COOK Residence 612 HIGHLAND AVE

### 612 Highland Avenue

### Smoot/Terrace Park Historic District Design Guidelines for New Construction

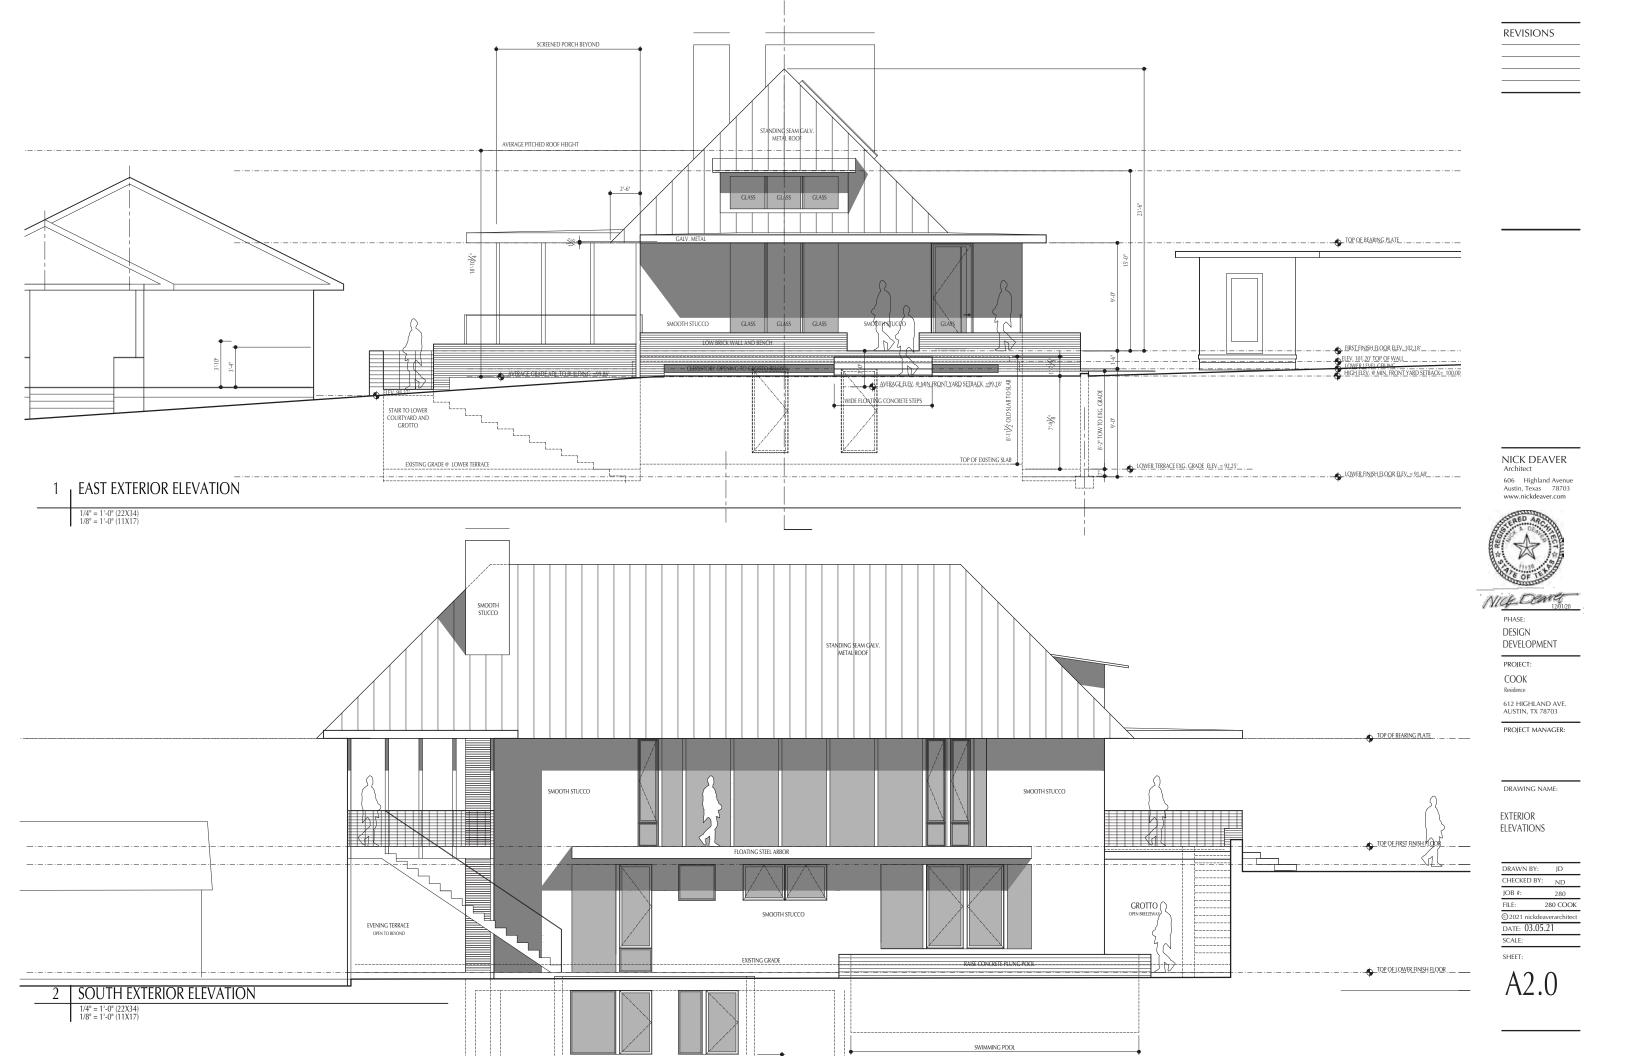
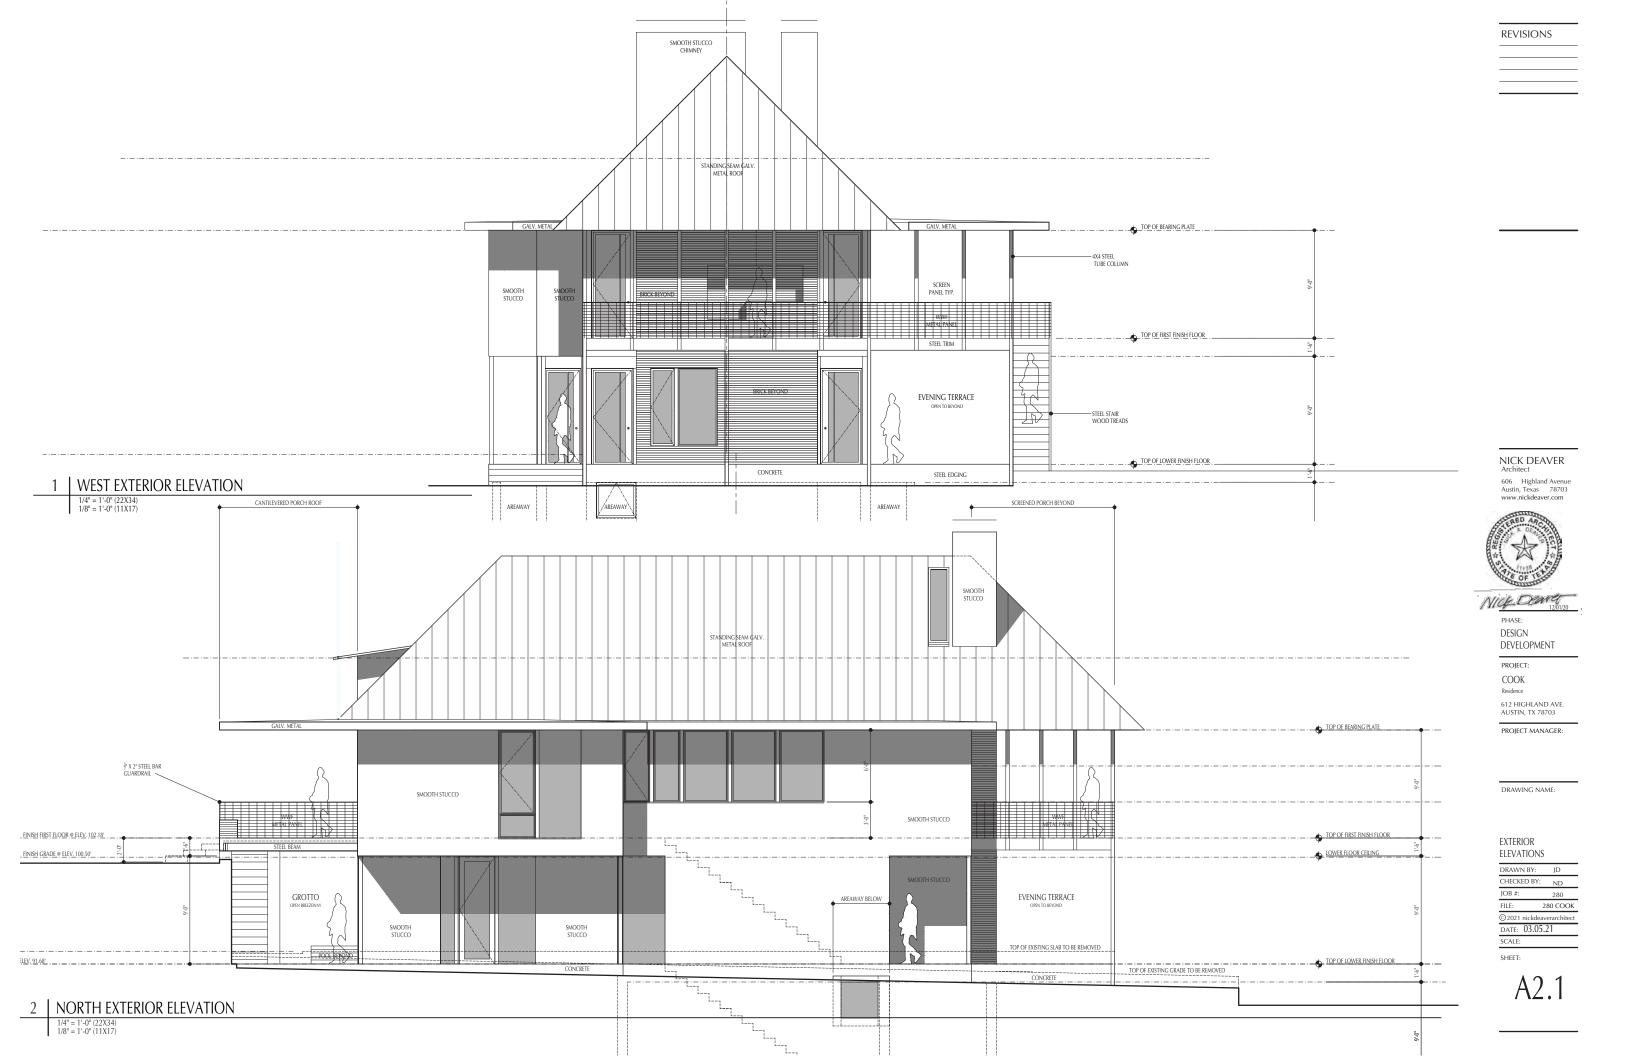
- 1.) Same street orienation and distance from adjacent buildings.
- 2.) Front yard setback aligns with setback of adjacent contributing house to the south.

- 3.) Compatible but differentiated from historic bungalows. Deliberatly departing from Craftsman Style with modern architecture that reflects its time.

- 4.) Reflects materials in the neighborhood. (Brick and Stucco, Standing Seam Metal Roof, Wood Porch Ceiling and Soffits.)
- 5.) Matches original footprint and eave heights of \*original structure, maintaining scale, massing, and spacing between houses. (Street pattern is 5' setback, open space for drive, house repeat)

- 6.) A modern house "not a historic style" with front proportions and fenestration patterns similar to neighbors.
- 7.) Simple hipped roof with front facing dormer and projected front porch.

- 8.) Deep building-wide front porch matching width, floor height, and ceiling height of the original structure. Maintains relationship to the ground.
- 9.) Single story with lower floor and outdoor garden at level below street grade.

- 10.) Separated Brick Landscaping wall from brick porch by 8" gap. (In repsonse to ARC comments 03.08.21)
